Tom Autrey began the meeting at 7:05 p.m. and explained the rules for the evening. Each small group will create a list of Pros and Cons for each segment of the Purple Line that Tom presented. The lists were compiled and additional comments were taken until September 9, 2008.

**Bethesda to Pearl Street (pages 2-5 of presentation)**

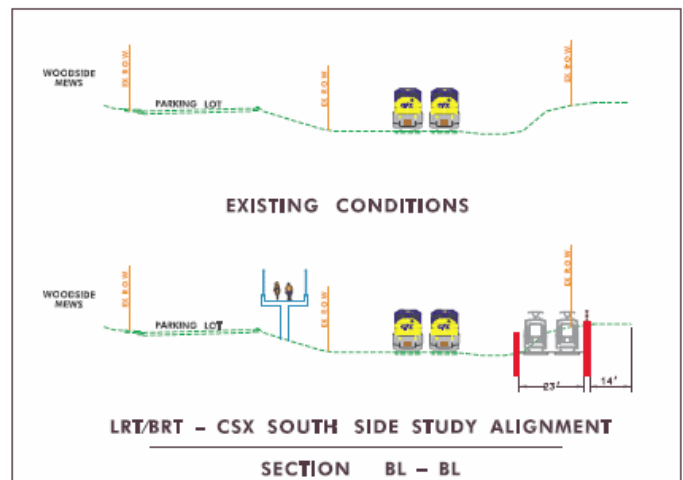
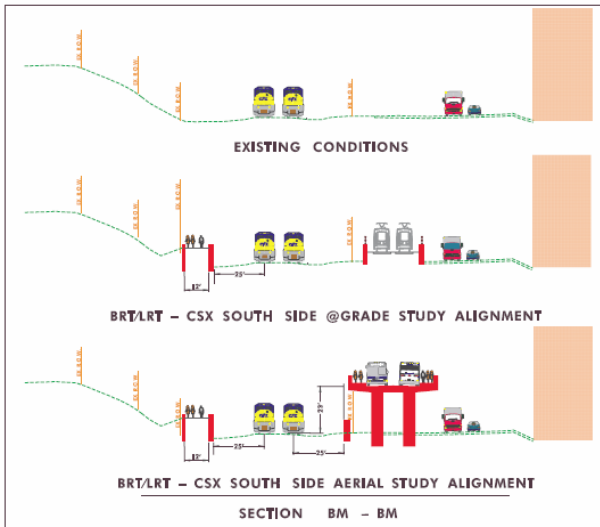
- *Is CSX okay with this option and using their ROW?*  
 The MTA is using guidelines provided by CSX for separation from other tracks in the right of way.
